Service Manual

KX-TS80SPW KX-TS85ALW
KX-TS85EXW KX-TS85GB
KX-TS85GW KX-TS85SPW

Supplement-1

This supplement has been issued for change the part No. of ROM and Electrical parts and Accessories.

■ ACCESSORIES AND PACKING MATERIALS (Change from original page 7)

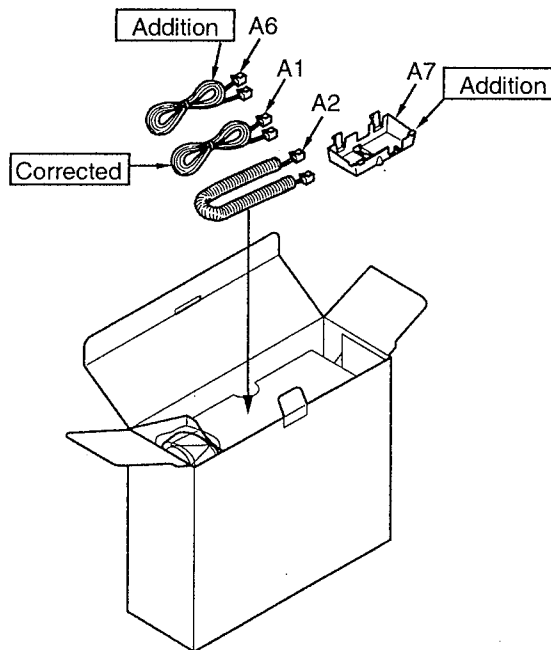
Ref. A1(shape of the plug) has been corrected from the original Service Manual.
